# Product Update Memo

SENSORS & CONTROLS PRODUCTS

May, 2006

## Bourns® Sensors & Controls Division Announces Model 39 Material Change

*Fortron Black*

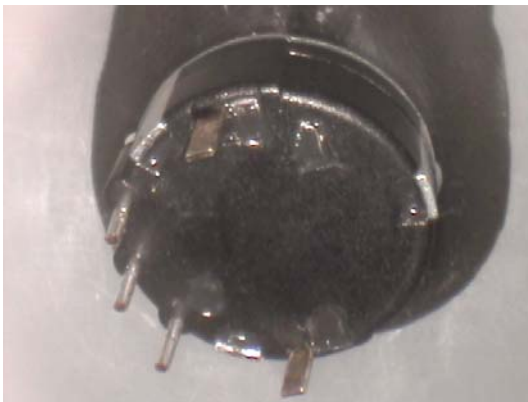
Sensors and Controls Division will be changing the plastic material used in molding the housing of our [Model 39](#). A change will be made from Fortron 6165A4 to Thermocomp® OF-1008 due to phase out of Fortron material at our current supplier and lack of availability from other suppliers.

Traditionally, the rotary switch and non-switch versions were made with natural colored Fortron, while the push switch version has been made with black colored Fortron. Please see the photos below.

In transitioning to the Thermocomp® material, we will discontinue the use of natural color material. The housings for both switch and non-switch versions will be black in color. There is no change to fit, form, or function.
